Project/File: **Ben's Crow Inn Subdivision/ BPP16-0003 / SUB16-00006**
 The applicant is proposing annexation, zoning, planned unit development and a preliminary plat application for a 24-lot residential subdivision on 4.2 acres on the west side of Warm Springs Avenue, north of SH-21.

Lead Agency: City of Boise

Staff Approval: March 15, 2016

PRELIMINARY PLAT FOR
BCI SUBDIVISION
 A PARCEL OF LAND LOCATED IN THE SE 1/4 OF THE NE 1/4 SECTION 33,
 T.3N., R.3E., B.M., ADA COUNTY, IDAHO
 2016

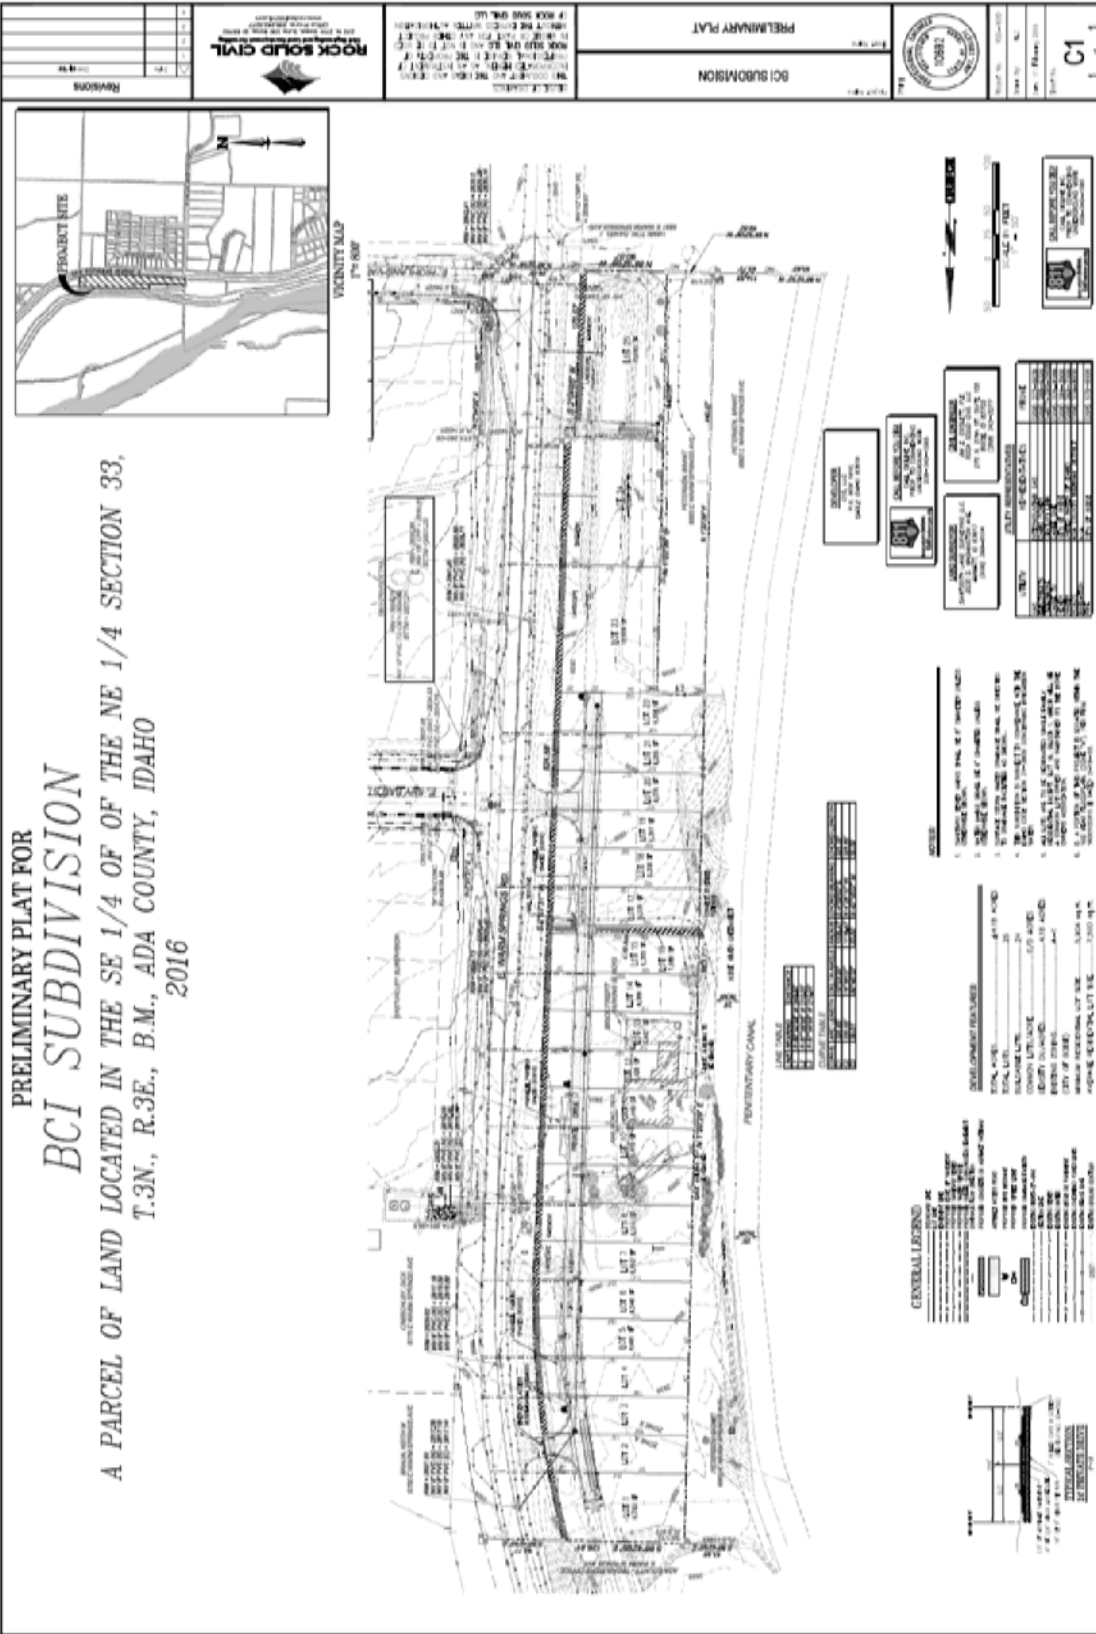
- c. **Staff Comments/Recommendations:** The applicant should be required to construct a 5-foot wide detached concrete sidewalk on Warm Springs Avenue, located as shown on the preliminary plat; and should provide a sidewalk easement for sidewalk that is constructed outside of the public right-of-way. The applicant is not required to widen the pavement beyond the 28-feet of pavement that exists on Warm Springs Avenue, as this is consistent with the overall width of Warm Springs Avenue north and south of the site. Until Warm Springs Avenue needs to be widened to include a center turn lane, there is no need to widen the pavement (by 3-feet) for this frontage. The applicant is proposing a connection to the Greenbelt through this site that will provide access to pedestrians and bicyclists.

The main entrance meets District policy and should be approved as proposed.

The shared driveway that serves 2 units does not meet District policy which requires 380-feet of separation on minor arterials (45MPH) between streets/driveways. This requires a modification of 55% for this dimensional standard. Staff recommends a modification of policy to allow this driveway because the driveway serves only 2 lots, and this site has only one other access, with 1,250-feet of frontage. The driveways will have adequate room on-site so that vehicles do not have to back on to Warm Springs Avenue. This modification can be approved at the Deputy Director level.

The emergency access is approved as proposed approximately 75-feet south of the north property line and over 650-feet north of the main entrance. Coordinate the bollards with emergency services. If the City requires the emergency access to be constructed as a regular driveway, not emergency access only, the location meets policy, and could be approved.

- b. Staff Comments/Recommendations:** If the City of Boise approves the private road, the applicant shall be required to pave the private roadway a minimum of 20 to 24-feet wide and at least 30-feet into the site beyond the edge of pavement of all public streets and install pavement tapers with 15-foot curb radii abutting the existing roadway edge. If private roads are not approved by the City of Boise, the applicant will be required to revise and resubmit the preliminary plat to provide public standard local streets in these locations.

1. Construct a 5-foot wide detached concrete sidewalk on Warm Springs Avenue, located a minimum of 31-feet from centerline; and provide a sidewalk easement for sidewalk that is constructed outside of the public right-of-way.
2. Construct a 24 to 30-foot wide driveway/private road on Warm Springs Avenue located in alignment with Sky Bar Street. Pave the driveway/private road its full width and at least 30-feet into the site with pavement tapers. Street name and stop signs are required for the private road. The signs may be ordered through the District. Verification of the correct, approved name of the road is required.

3. Construct a 20 to 24-foot wide driveway on Warm Springs Avenue located 170-feet north of Highland Valley Road. Pave the driveway its full width and at least 30-feet into the site with pavement tapers.
4. Construct a 20-foot wide emergency access on Warm Springs Avenue located 75-feet south of the north property line. Pave the driveway its full width and at least 30-feet into the site with pavement tapers. Coordinate the location and installation of bollards with the Boise Fire Department.
5. Payment of impacts fees are due prior to issuance of a building permit.
6. Comply with all Standard Conditions of Approval.
